## Republic of the Philippines NATIONAL PRIVACY COMMISSION BIDS AND AWARDS COMMITTEE

## SUPPLEMENTAL/BID BULLETIN NO. 001-2022

SUBJECT: SUPPLY AND INSTALLATION OF MODULAR TYPE WORKSTATIONS AT NPC OFFICE

## 1. 2-Seater Workstation (Modular Type)

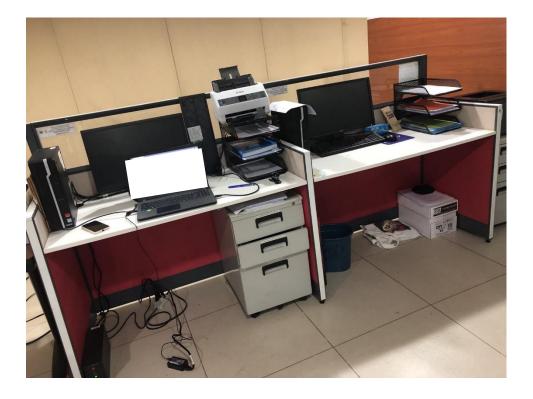
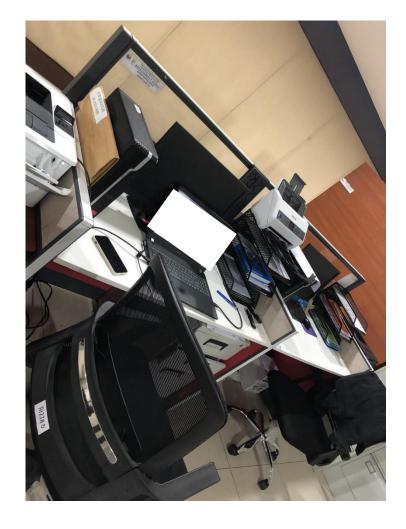
CLARIFICATION/ QUESTION	ADDENDUM/AMENDMENT/ ANSWER
What is the position of the seats? Side by side or facing each other?	-Seats must be side-by-side
What is the thickness of the tabletop of the workstations?	-Thickness for the tabletop is at least 2.0 cm.
	-Length should be 120cm.
	-Width should be 60cm.
What is the thickness of the sidings or footings of the workstations?	-not less than 3.2cm but not to exceed 5.0cm
What is the height of the workstations?	-The height for the workstations should be 120cm inclusive of the glass
	partition and 4cm. footing
Location of the raceway	-Raceway should be at the bottom part of the workstation
Location of the grommet	-Grommet can be anywhere (left, right or center) of the front-end of
	the tabletop
Are the workstations two-tone?	-One color fabric, either red or blue

Attached are the actual pictures of the sample. Almost the same appearance and dimensions except for the single fabric color (red or white) and no longer two-tone.
